# STAFF REPORT

## CONCERNING APPLICATION FOR A CERTIFICATE OF APPROPRIATENESS

**Application Number:** 2018-1113A

**Property Location:** 702 N St Joseph

*Figure 3 - 702 N St Joseph, taken on November 11th.*

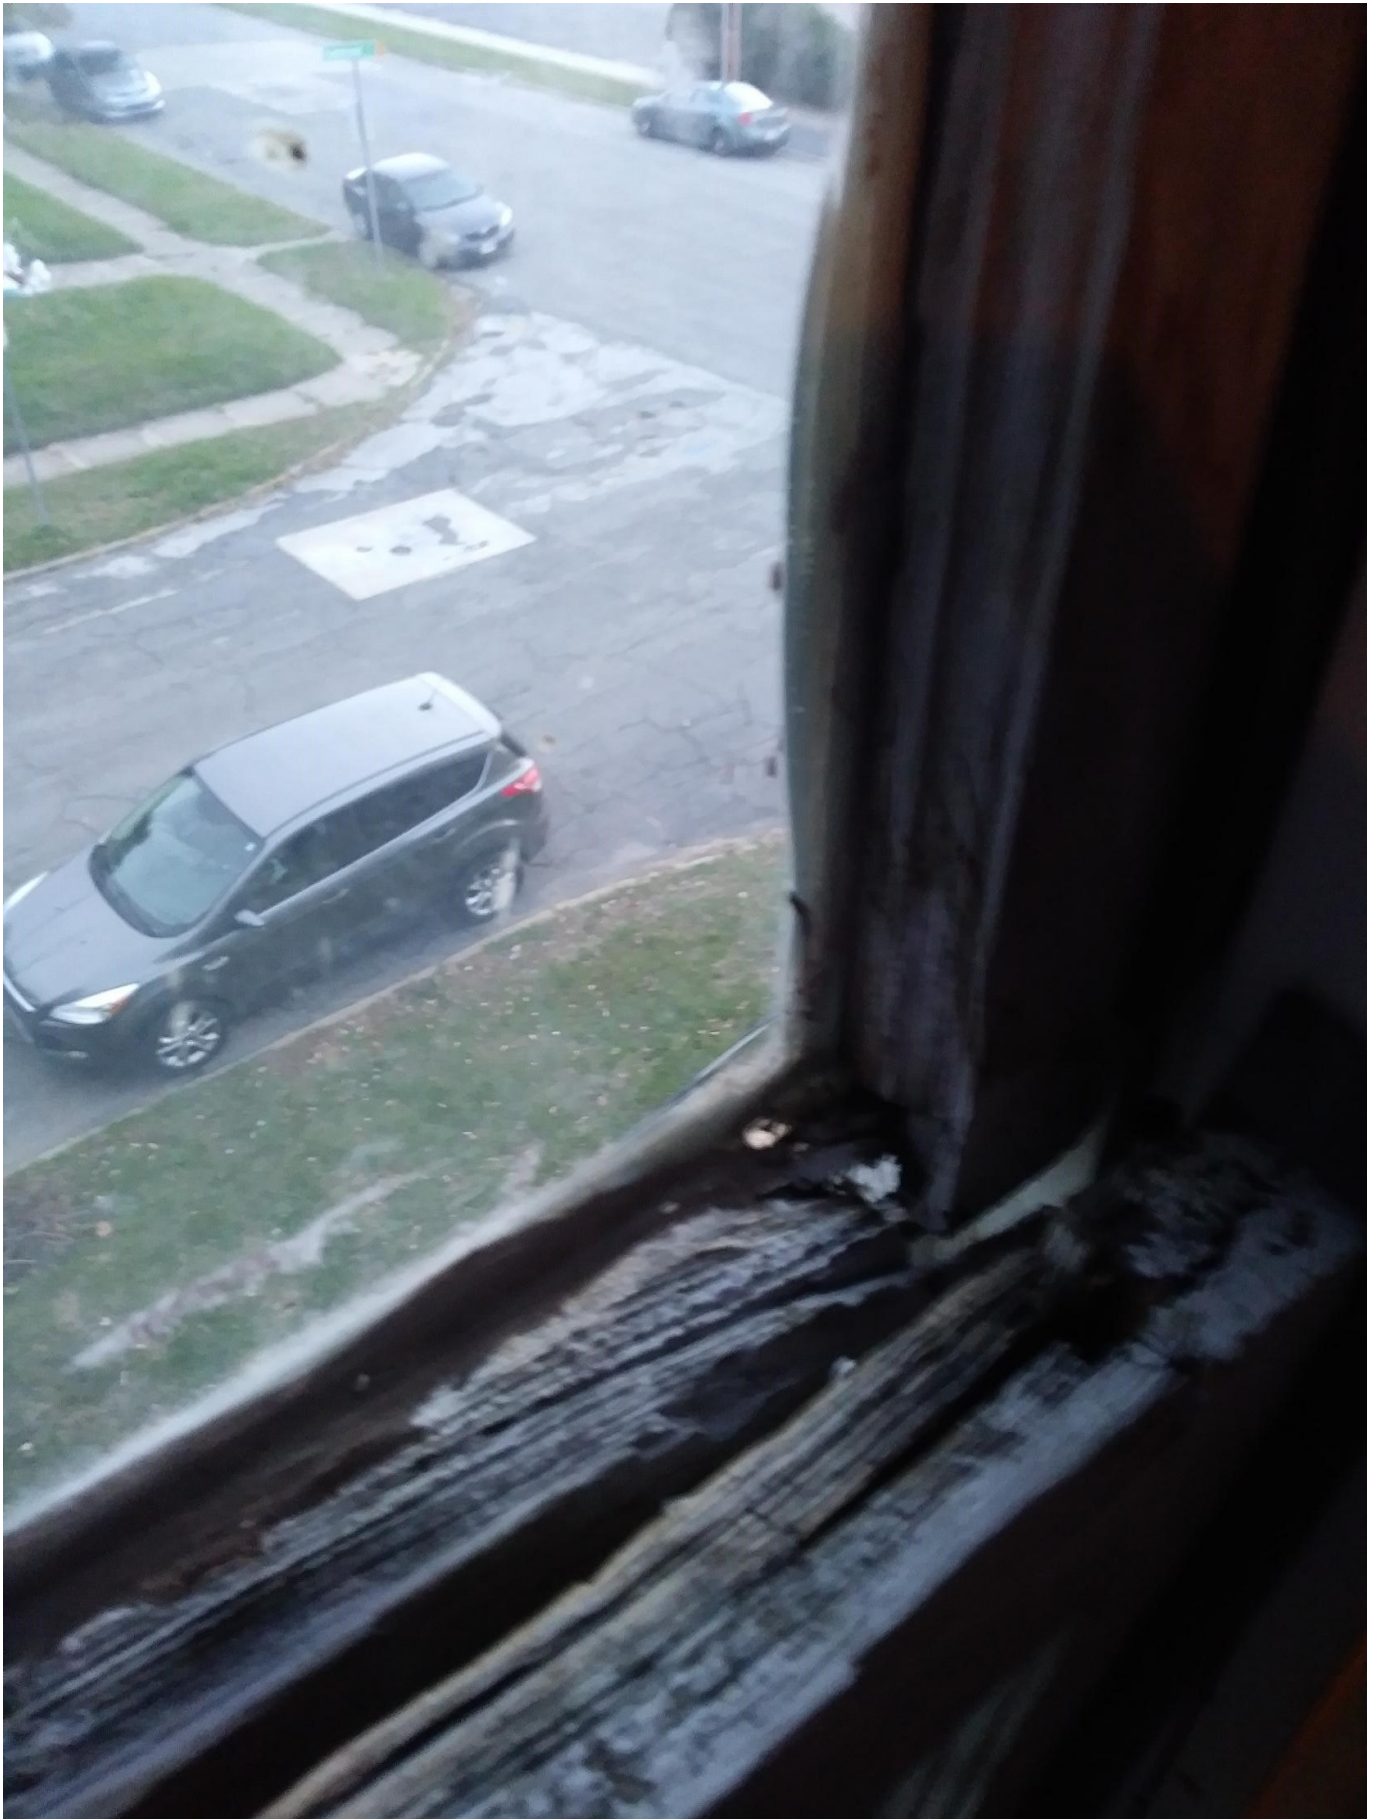
On November 12, 2018 I met with the owner of the property located at 702 N St. Joseph. She has applied to replace the windows located on the south-facing third floor dormer. I was unable to go inside the structure as the tenant works from home and did not want to be disturbed. I photographed the windows from the outside and was able to determine that the one of the four sashes would need to be replaced or be rebuilt. The meeting rail of the top sash is broken free. The other window has the sashes reversed meaning upper forced down and lower sash forced up. The sashes do not look to be in place.

**STAFF RECOMMENDATION:** Staff concedes that one of the sashes is extensively deteriorated. Replacement of the windows with an aluminum-clad window model is supported, although staff would prefer to see the original “two-window” format be replicated.
